NCSX Document and Records Plan Peer Review

Date: March 19, 2003

Resolution of NCSX Document and Records Plan Peer Review Chits, conducted on March 14, 2003, has been successfully completed and all CHITs closed out.

Figure 2.2-4

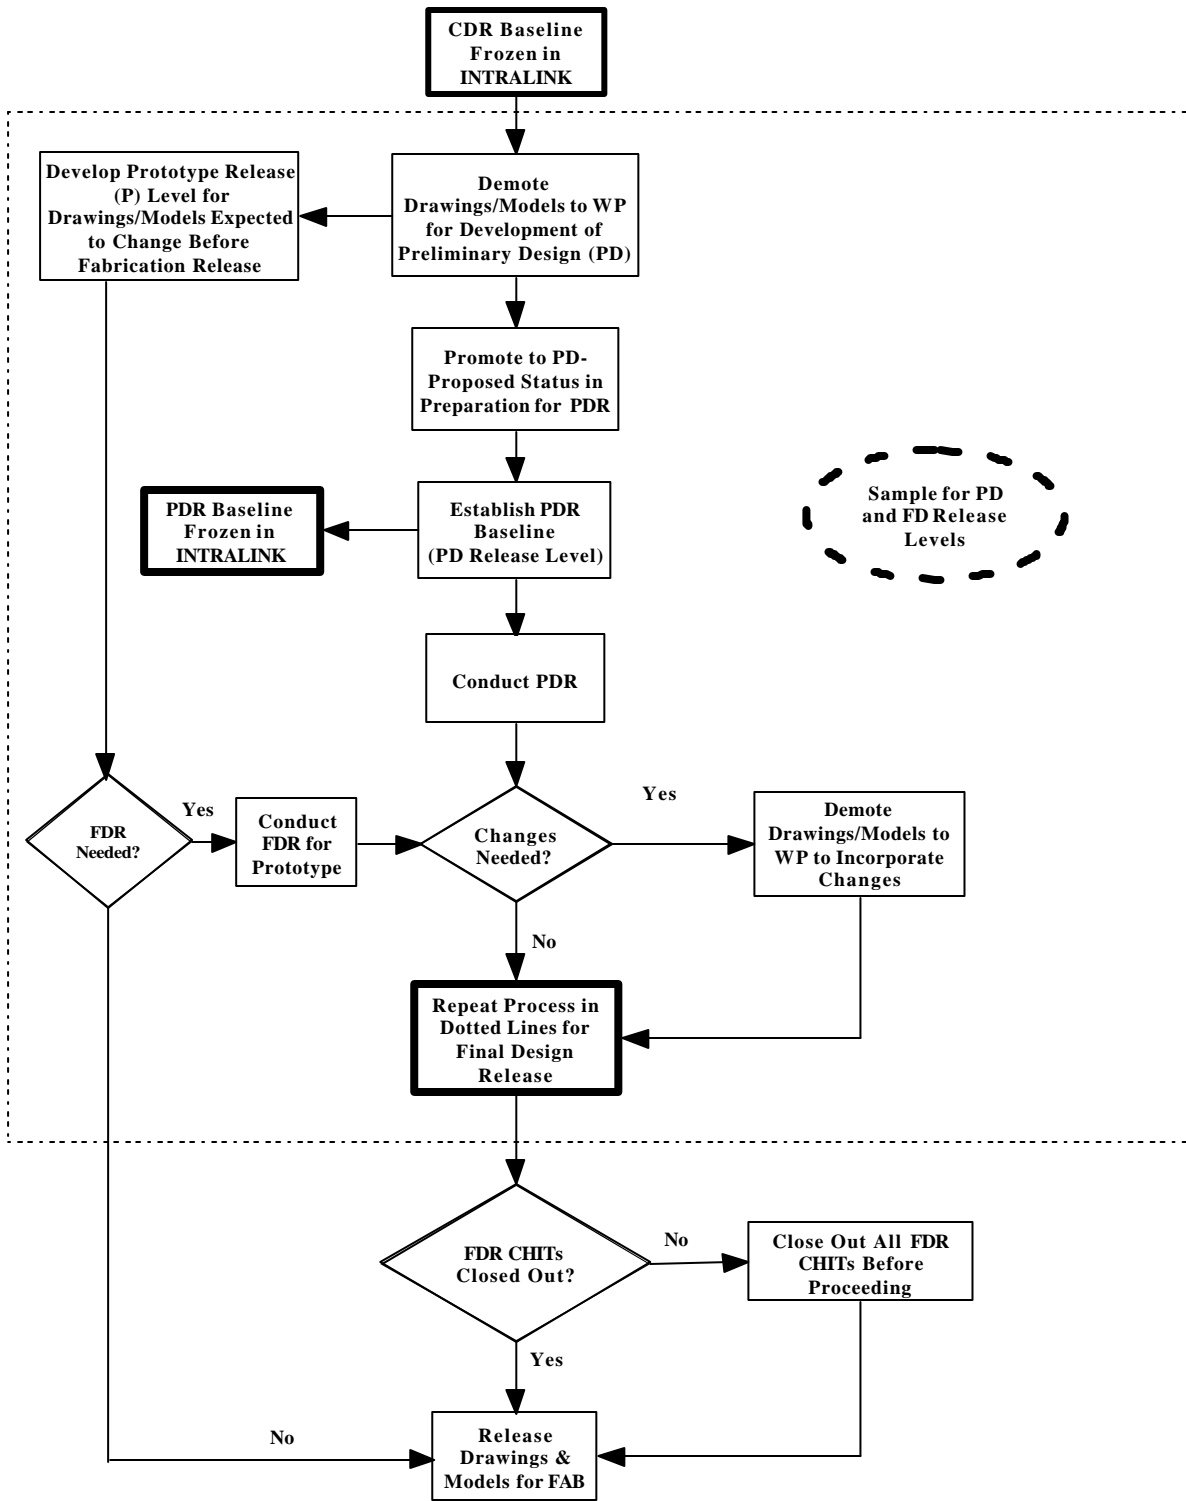
CHIT # 9COMPONENT/SUBSYSTEM/SYSTEM NCSX Data Management Plan PEER CDR PDR FDRCOGNIZANT DESIGN ENGINEER R. Simmons DATE OF REVIEW 03-31-03**SUBJECT: (CHECK AS APPLICABLE)** REQUIREMENTS HARDWARE SAFETY ANALYSIS CONFIGURATION COST/SCHEDULE PERFORMANCE RELIABILITY/MAINTAINABILITY QUALITY**COMMENT/CONCERN/RECOMMENDATION**Revise drawing release flow diagram – design baseline established going into review.ORIGINATOR W. ReiersenNAME/ORGANIZATION MED**REVIEW BOARD COMMENT/RECOMMENDATION**

Figures 2.2-4 and 2.2-5 revised to reflect correct flow of documents
